NC STATE UNIVERSITY CATES AVENUE MASTER PLAN

July 16, 2010

- 5. Appendix** **72**
 - June 28 Design Review Comments 72

Project Name: Cates Avenue Master Plan Study

VICINITY PARKING COUNT

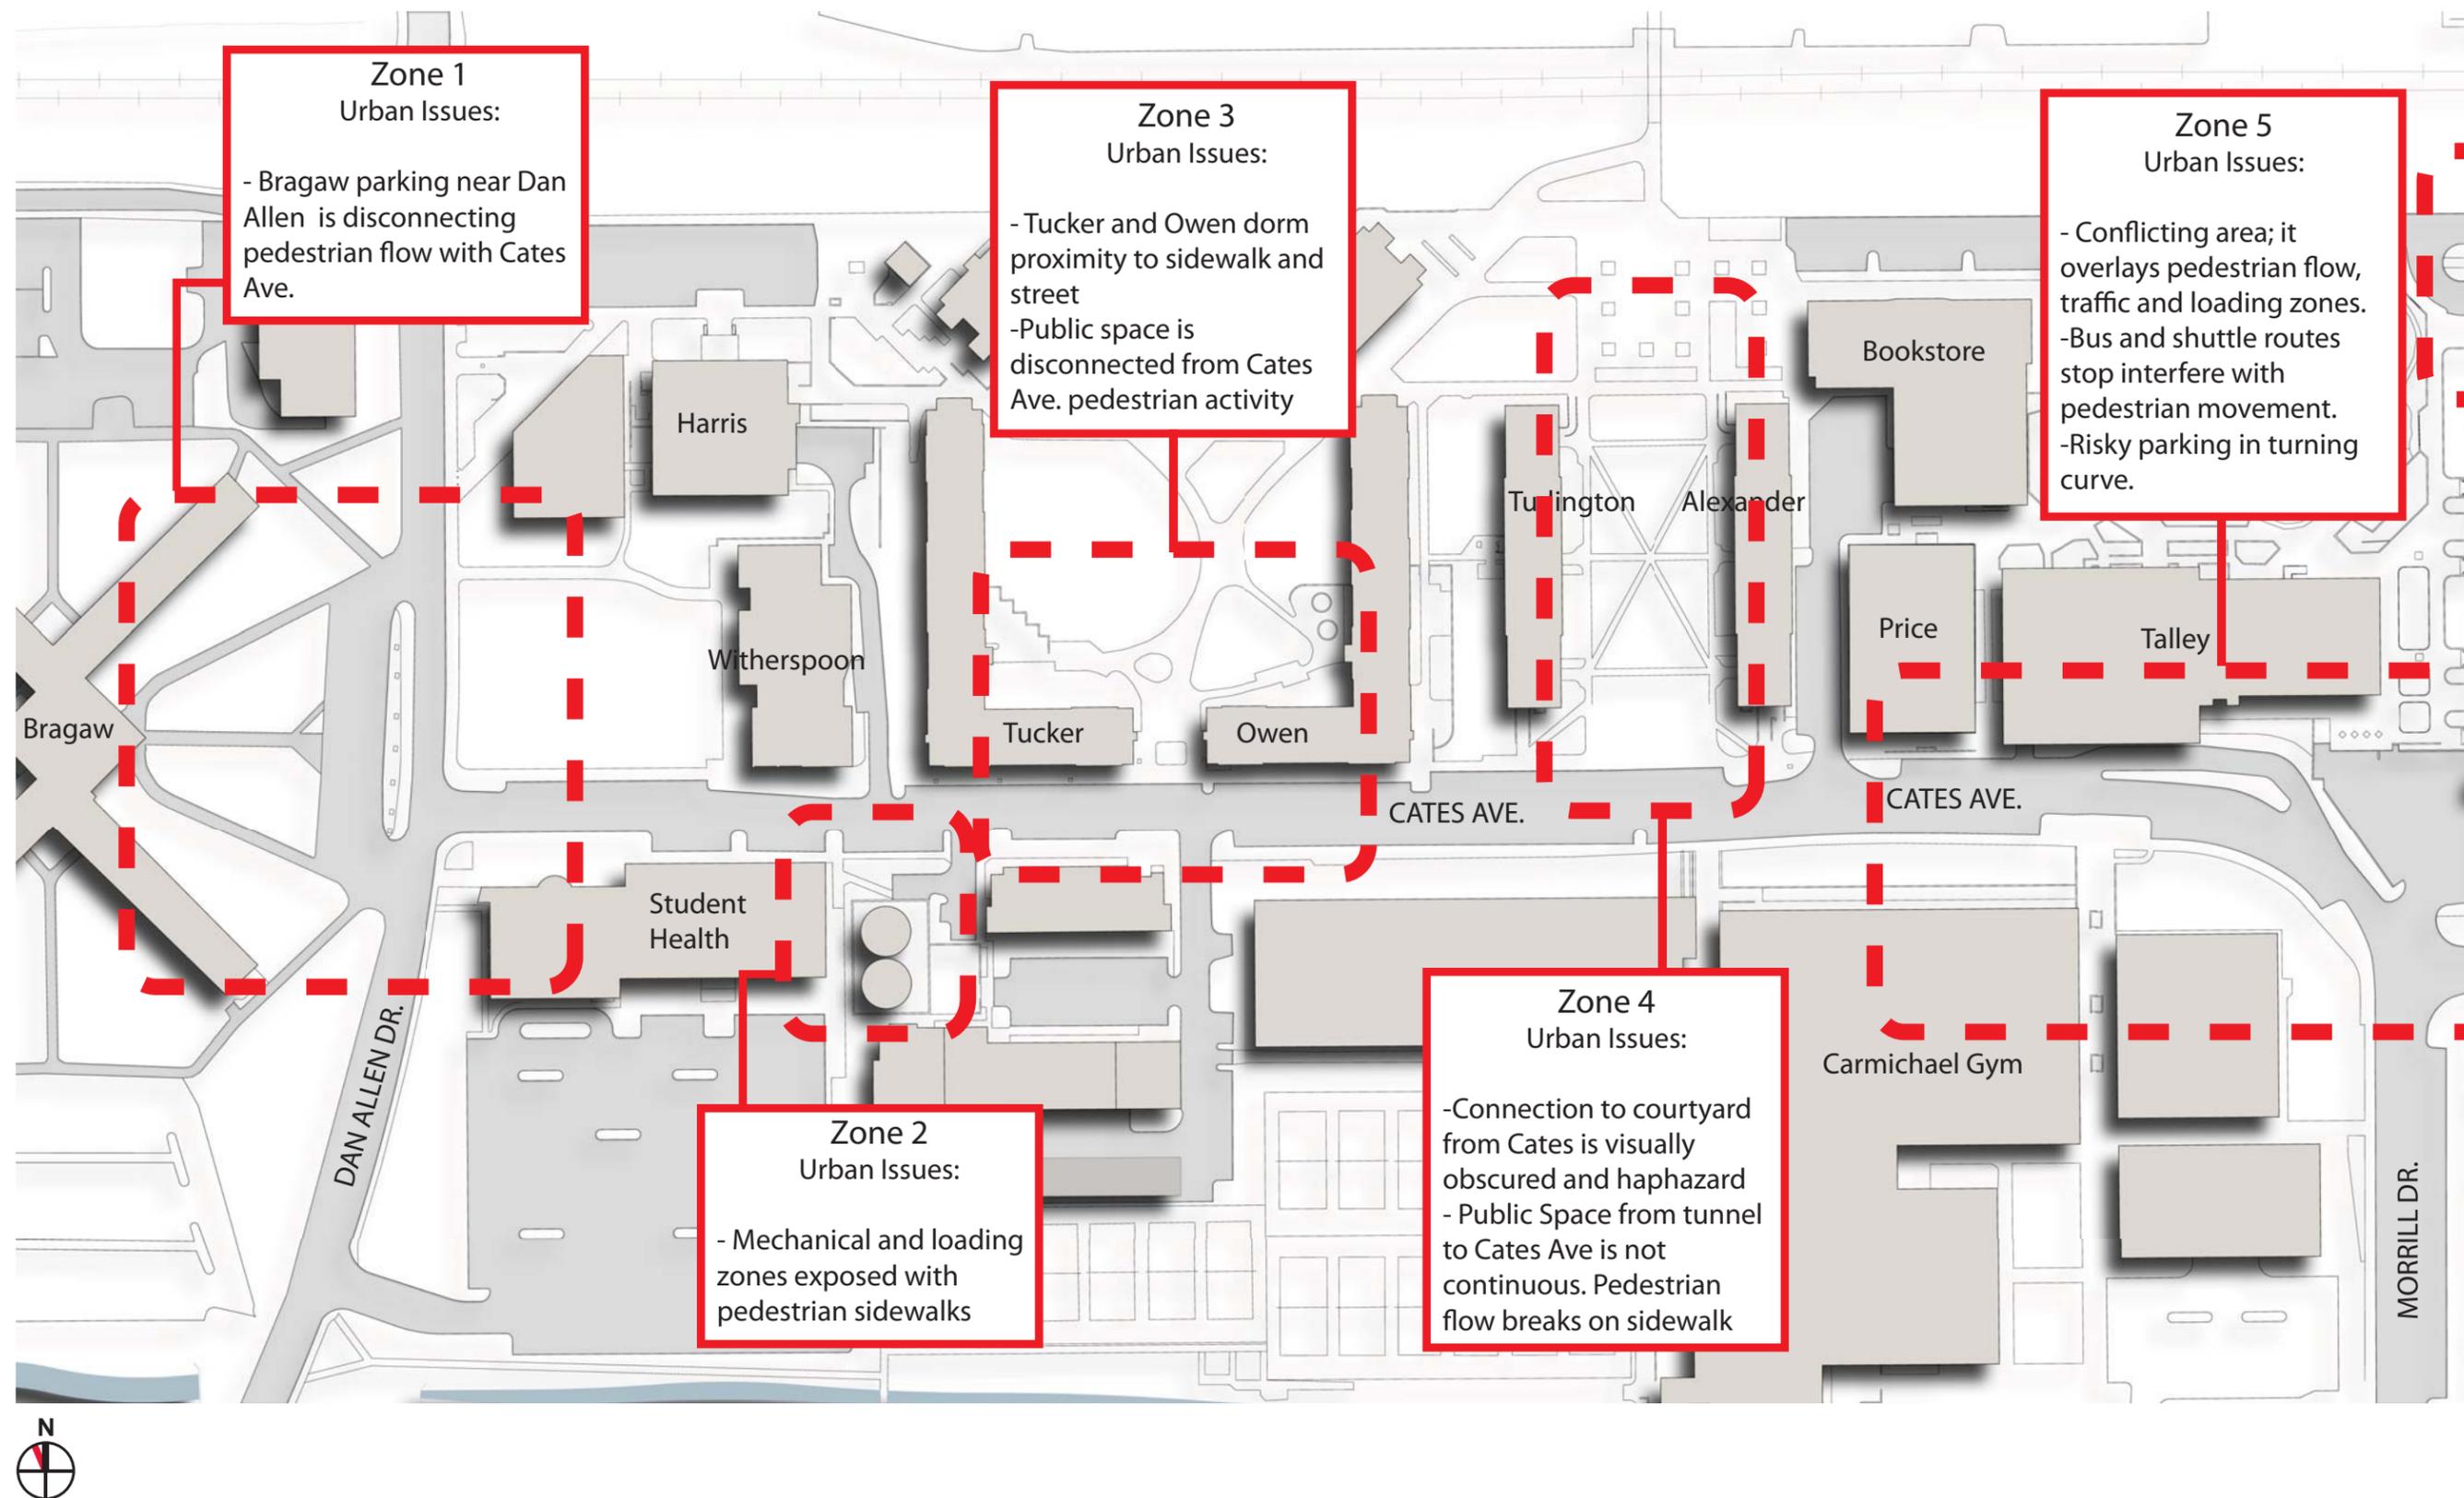
7. Pgs 15 & 16 – HC should be used as the code to identify accessible spaces, not AS. AS is actually the code we use to identify reserved assigned spaces on campus.	7. Document is amended to reflect comment.

10. Pg 16 – Under Red, Green and Pink zones, change AS to HC.	10. Document is amended to reflect comment.
11. Pg 16 – Can you please identify what constitutes the 31 priority parking spaces? Not sure Transportation was involved in the development of this number or the priority.	11. It was recommended that the design team consider RD, LO, SV, and HC parking spaces as the priority spaces. It was suggested that incremental relocation of RE spaces could occur in various locations around campus. NOTE: This study has only attempted to basically quantify the difference between the number of parking spaces that currently exist and the projected number if parallel parking was implemented entirely along Cates Avenue. The master plan has not identified specific relocation of space types and assumes the NCSU transportation would coordinate this.
